STAFF REPORT
Planning Commission Meeting September 25, 2017
Updated for December 18, 2017

PROJECT NUMBER / TITLE: Application # 17-08

REQUEST: Preliminary Site Development Plan for Martway Mixed Use Development

RE: Maryway Mixed Use/Mission Trails Final Preliminary Plan Case #17-08-Staff
Review Comments

SITE PLAN

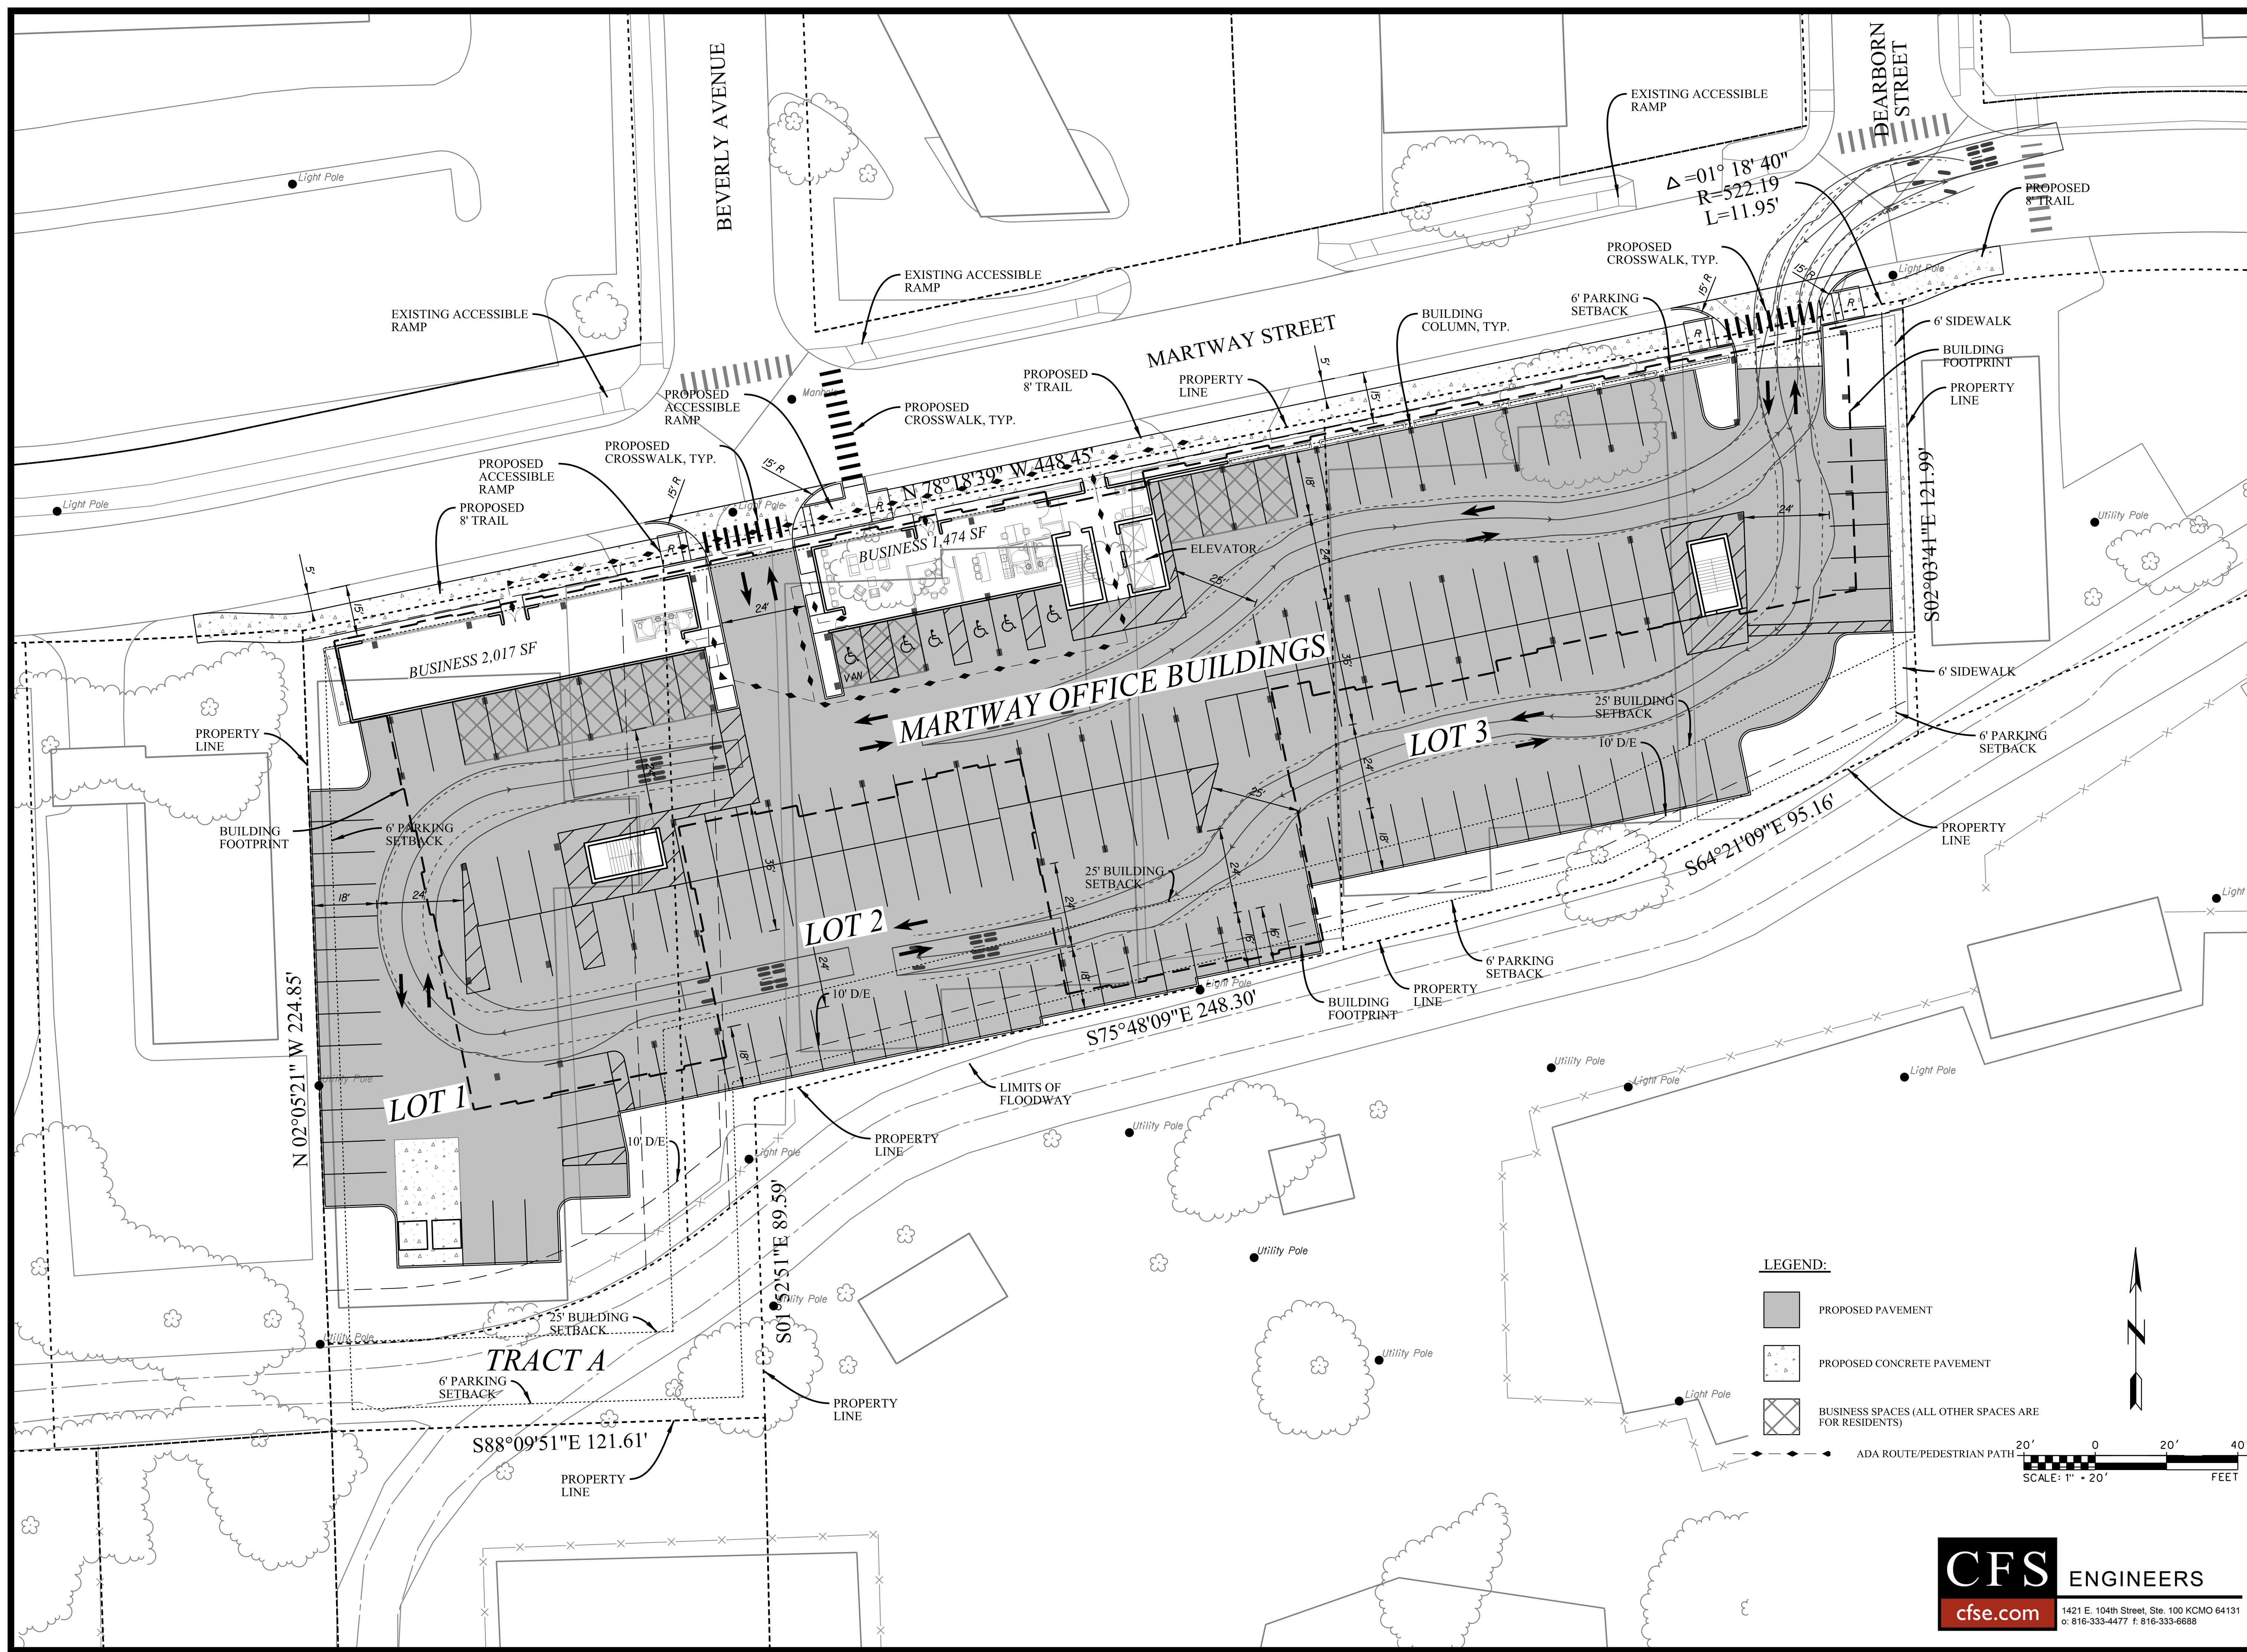
3. Show striping or linework to indicate vehicle circulation within parking area. There is a concern with vehicle flow within parking lot.

6. The parking spaces along the east side of the property are directly adjacent to the driveway. Provide an adequate throat length (50' min.) to allow for vehicle queuing and reduce potential conflict when vehicles enter/exit the property via that drive and enter/exit parking spaces.

Circulation arrows have been added to the site plan.

The parking layout has been revised to provide a 40' throat length to match the island adjacent to the easterly parking spaces.

PROPOSED FLOOD PLAIN PLAN

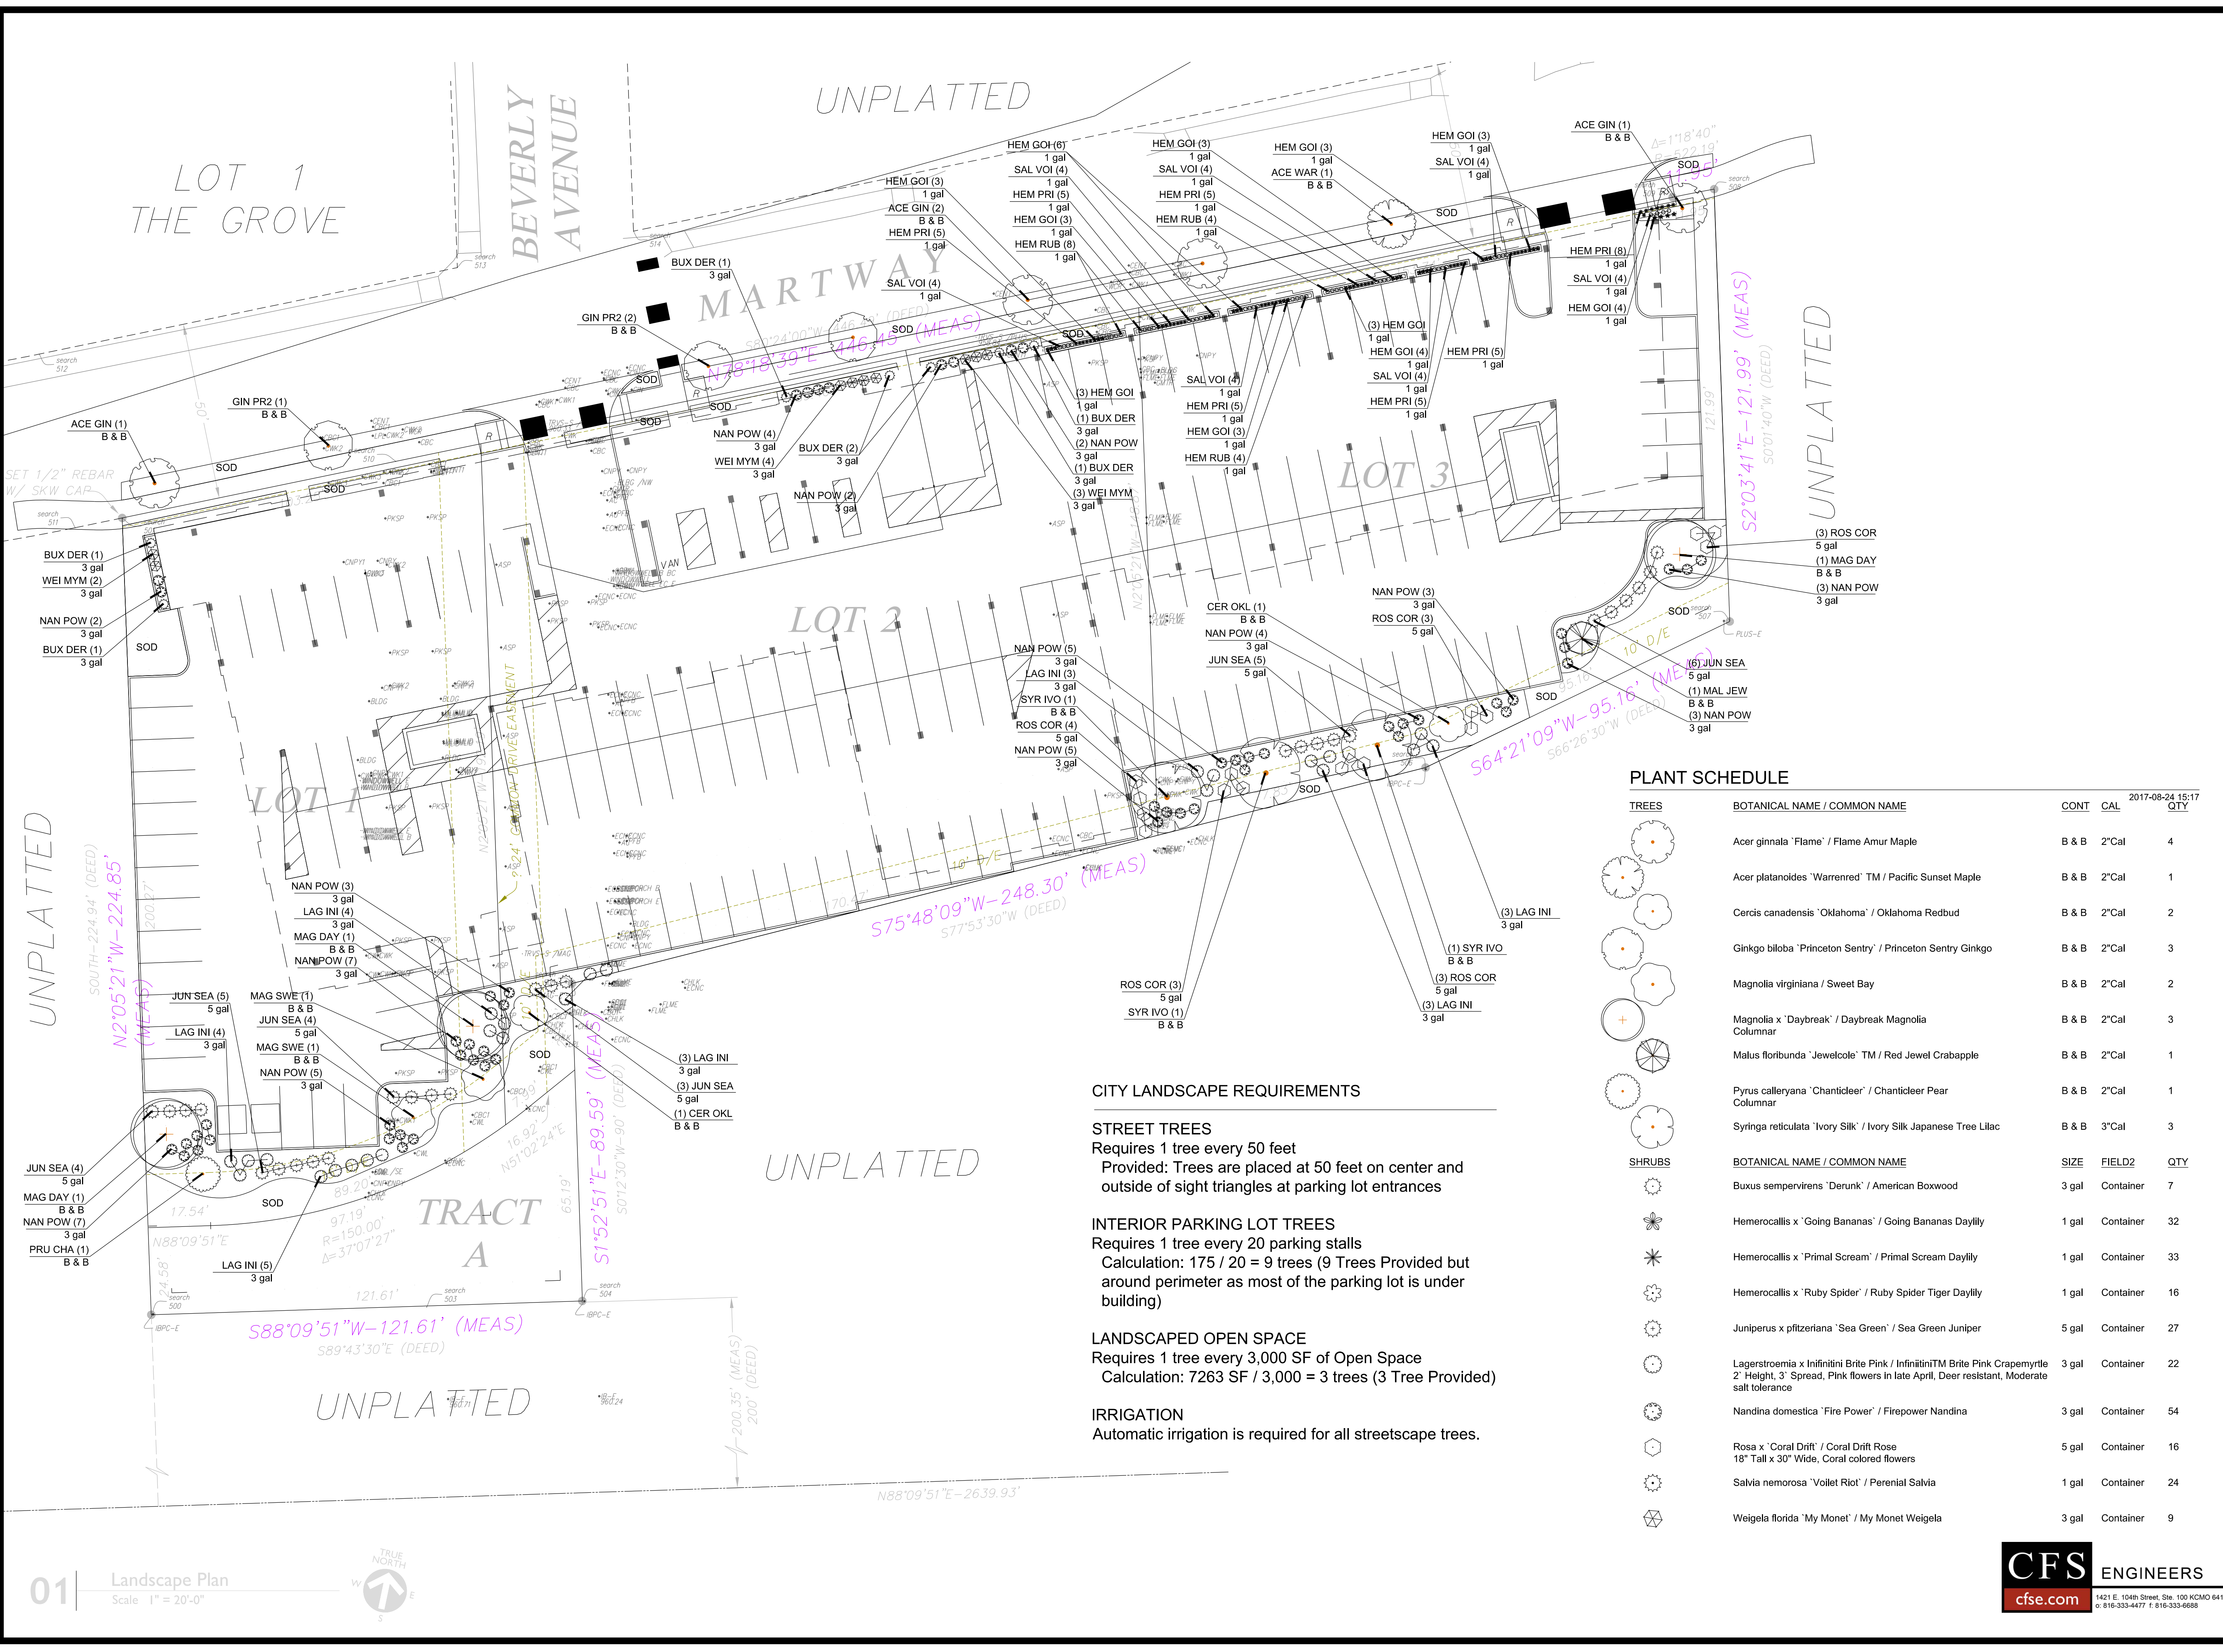
2. Provide the maximum 100 year floodplain depth in the parking lot. 7" depth is the maximum allowed.

The 100 year floodplain limits over parking lot have been shown on Sheet C-203, Proposed Floodplain Plan. The parking lot has been graded such that no parking stall would pond over 7" based on the FEMA floodplain depths.
